Lewis River Interim Final Upstream Transport Plan

**Lewis River Upstream Transport Plan**  
**Interim Final**

**Comments on the draft Upstream Transport Plan with responses**

**SUBJECT: Draft Lewis River Upstream and Downstream Plans**

Figure 2.0-1. Merwin Trap capture timing by species (last update 11/3/2009).

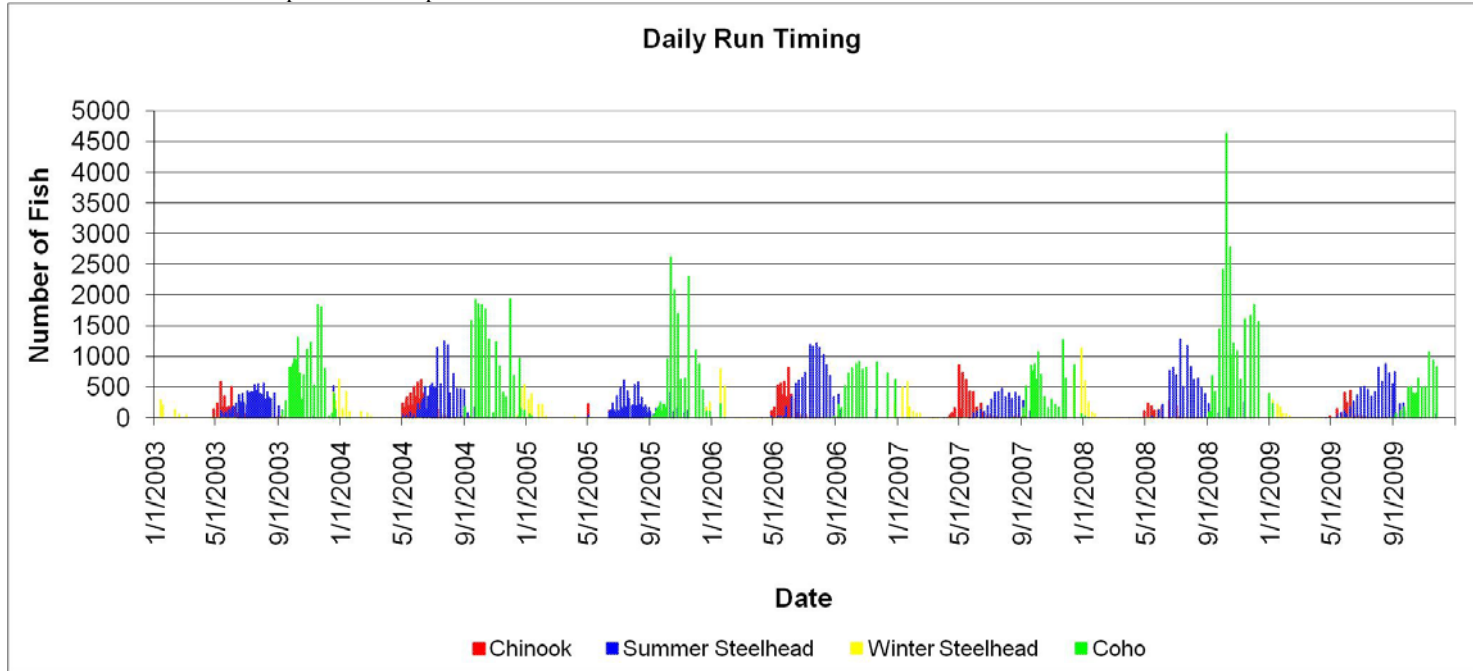
Commented [M15]: Figure needs legend for yellow and green. One of those colors is coho, right?

*Figure was repaired and updated*
